Manufacturing Notice

Name:	Final Finish on Flip-Lid Ashtray Insert
-------	---

Affected Parts:	All Flip-Lid Ashtray Inserts (FLA).
Part Names:	Rim and Lid

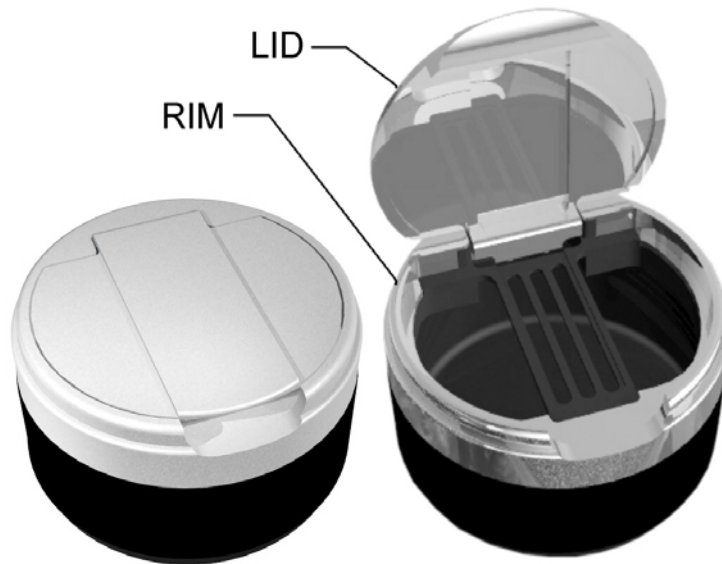
IMPORTANT PLATING INFORMATION

Aluminum parts for the Flip-Lid Ashtray have been precision machined to provide tolerances for normal plating thicknesses and possible clear coat finishes. Avoid heavy build-up or pooling of any final finish on surfaces and corners as this will prevent the ashtray from operating properly.

Name:	Final Finish on Flip-Lid Ashtray Insert Lid
-------	---

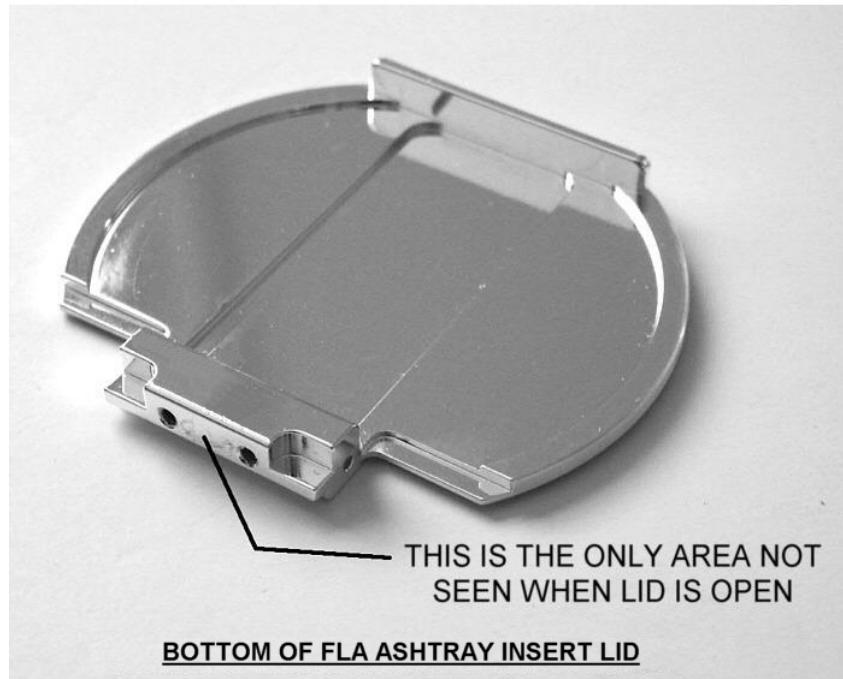
IMPORTANT PLATING INFORMATION

Except as indicated, all areas of the lid are visible during normal operation.
